American Car & Foundry Co.,
Engineering Dept.
Berwick Pa.
30" Motor Wheels & Axle
For
Shawmut Mining Co.

Folio	X.Y.
No	864

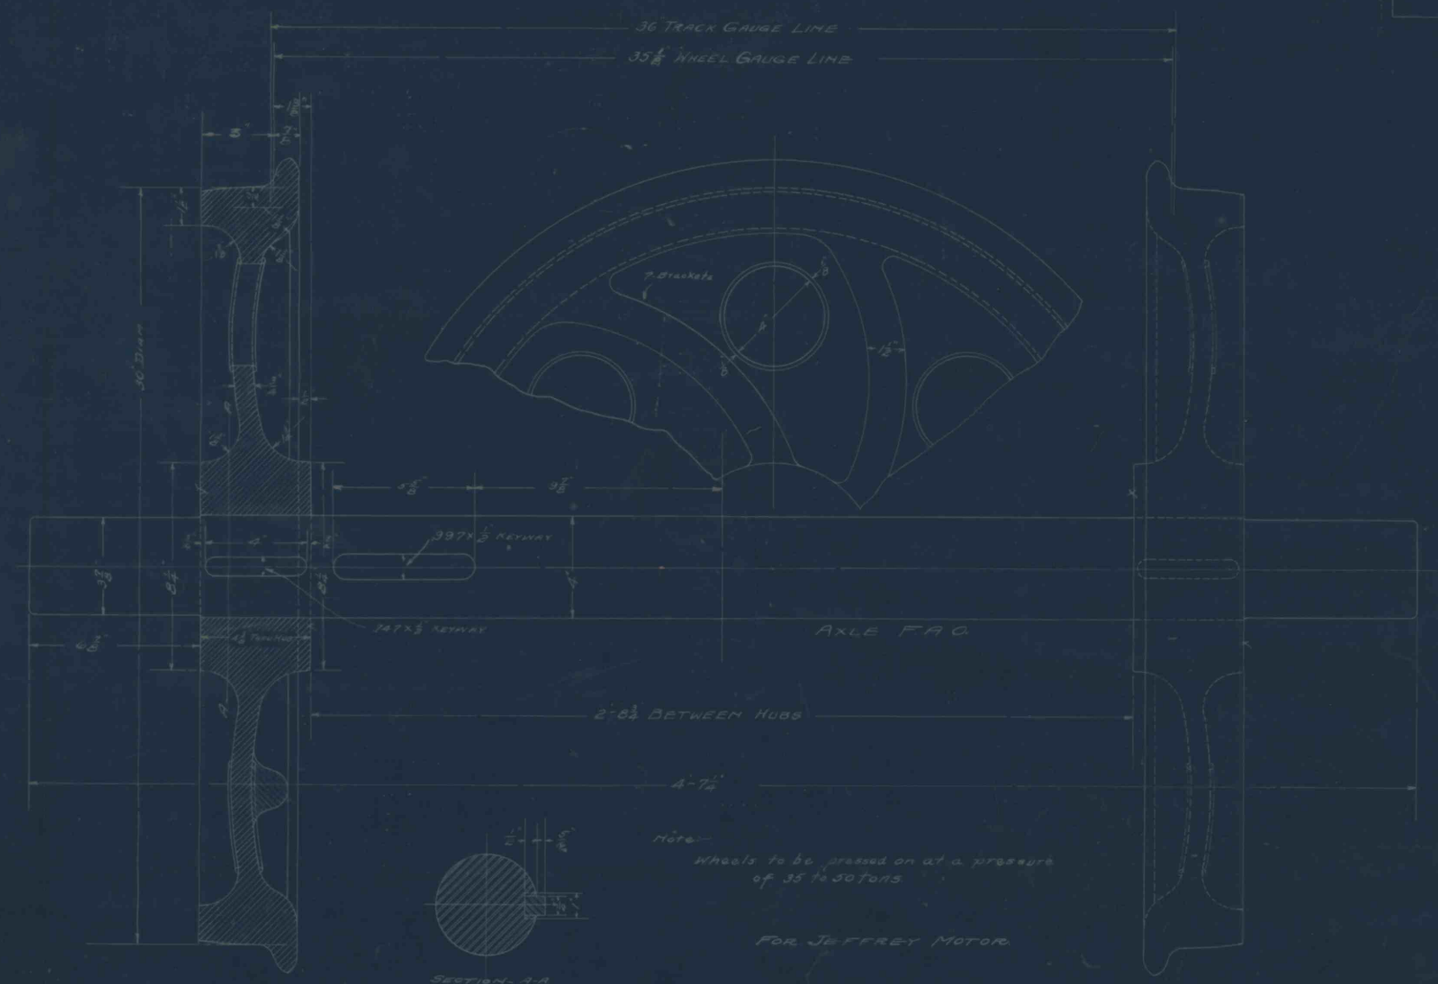
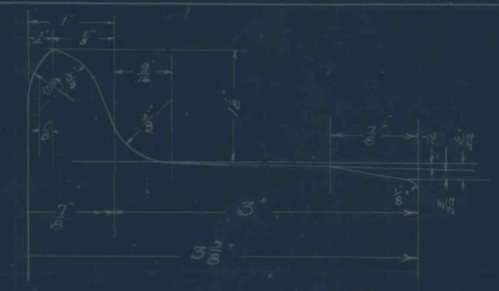
Reduce A only, Dec 19-13. Flange changed from 1 To 7/8
Tread From 2 1/2 To 3"
Inside Fref From 1 3/8 To 1 5/32"
Wheel Gauge Changed From 35 3/4" To 35 5/8"
